Office Action Summary

09/761,375

WILLIAMS, TERRY N.

DETAILED ACTION

**FIG. 40**

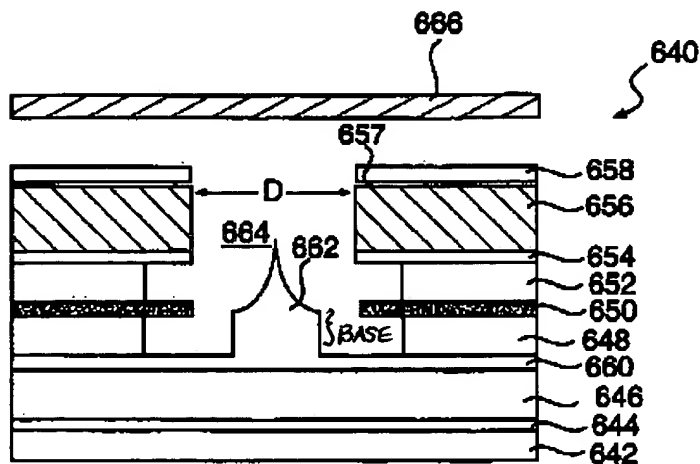
6. With respect to claims 9, 12, 15, and 20, Jones et al. disclose a field emission device comprising a substrate (Fig. 40, 642 & 644); a cathode conductive layer (646) disposed over the substrate; and an emitter tip (662) integral with an emitter layer (660) disposed over the cathode conductive layer and having a base adjacent to the emitter layer, an apex, and a continuously concave exterior surface extending from the base to the apex. Jones et al. also disclose: the exterior surface having a substantially

paraboloid vertical profile that extends from the base to the apex; and the exterior surface having an ovoid profile that extends from the base to the apex.

8. With respect to claims 10, 13, and 16, Jones et al. disclose a conductive gate structure (Fig. 40, 656 & 658) disposed over the cathode conductive layer (646); an aperture (664) through the conductive gate structure, the emitter tip (662) being

exposed within the aperture, and an anode panel (666) positioned over the conductive gate structure and the emitter tip.

11. With respect to claims 11, 14, and 17, Jones et al. disclose an anode conductive layer (Fig. 40, 666), and a phospholuminescent panel for emitting light upon being excited by electrons (column 10, lines 33-39). Jones et al. do not disclose a transparent panel. However, it would have been obvious to one of ordinary skill in the art to modify the Jones et al. invention and disclose a transparent panel in order to provide image output capability of the display device.

**FIG. 39**

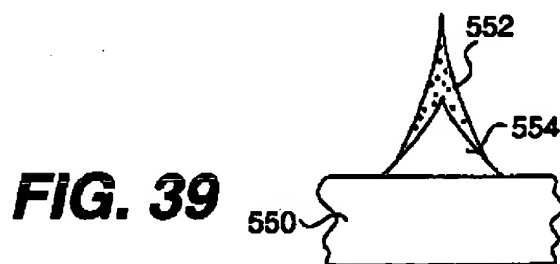
7. With respect to claim 18, Jones et al. disclose a field emission device comprising an emitter tip (Fig. 39, 554) formed from an emitter layer, the emitter tip having a height and including a base and an apex, wherein the emitter tip is generally conical and has a substantially rectilinear profile between the base and the apex.
